File No. 251098 **Committee Item No.** _____
Board Item No. 23

NOTICE TO BOARD OF SUPERVISORS OF APPEAL
FROM ACTION OF THE CITY PLANNING COMMISSION

The property is located at **350 Amber Drive**, SAN FRANCISCO, CA 94131.

RE: Notice of Appeal and Reasons in Support of Granting the Appeal of the September 25, 2025 Planning Commission Approvals of the AT&T Monopole Facility Project at 350 Amber Dr., San Francisco, its Conditional Use Authorization, and Shadow Findings (#02024-004318CUA)

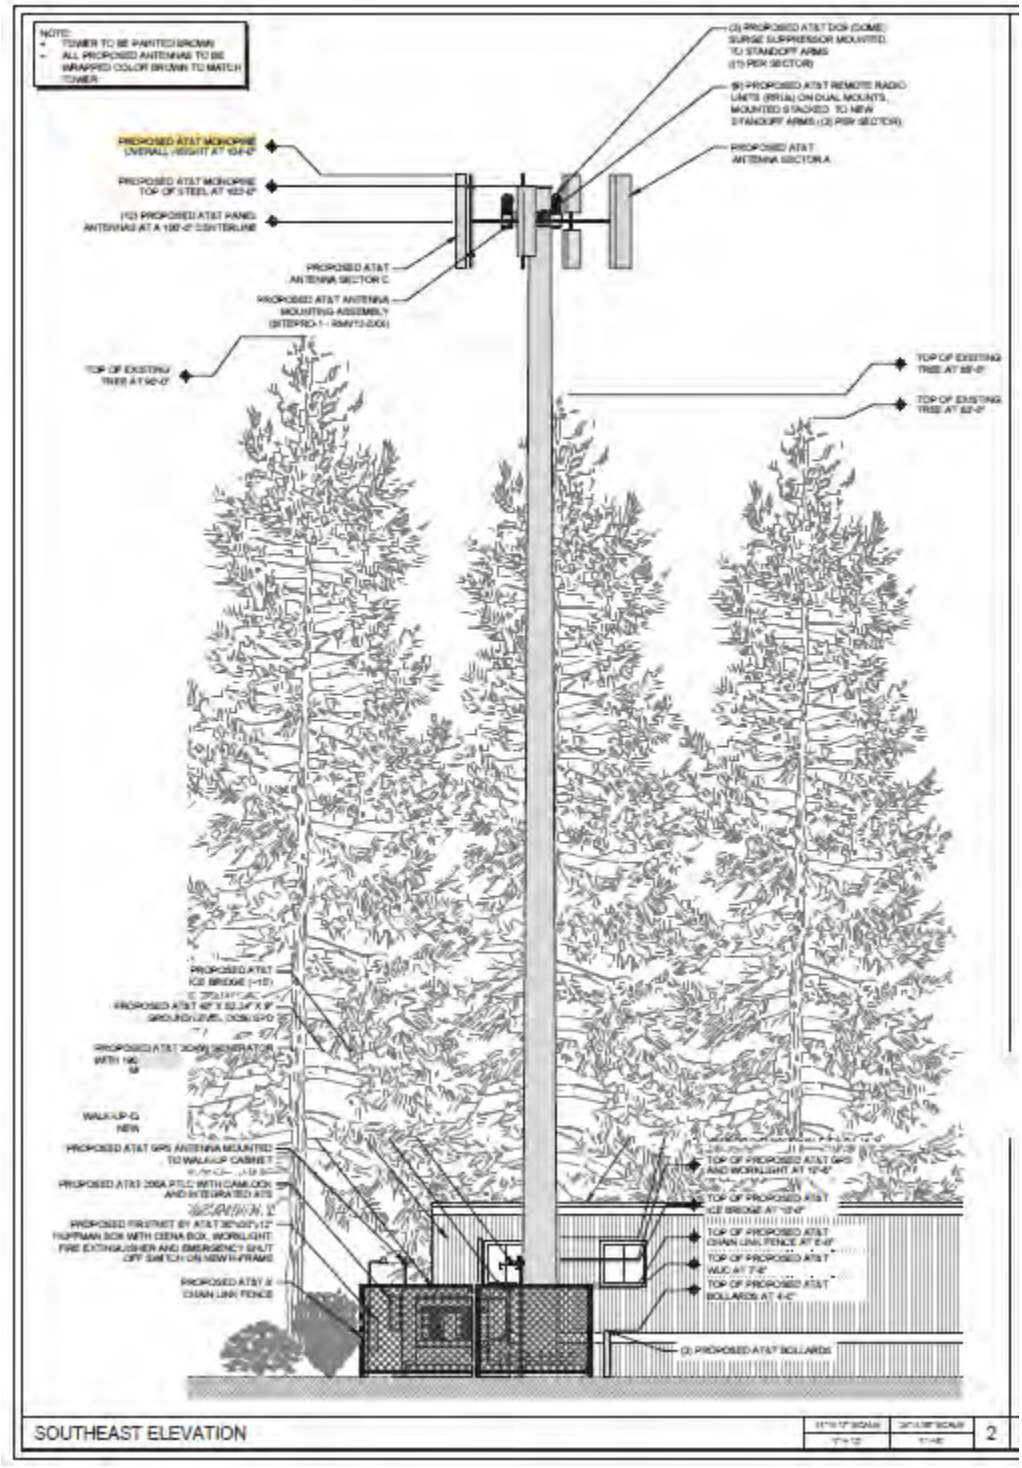
To wit, the Project proposes a 104-feet tall monopine or monopole, surrounded by 90-feet eucalyptus tree grove, as depicted on the screenshot from the Project plans below:
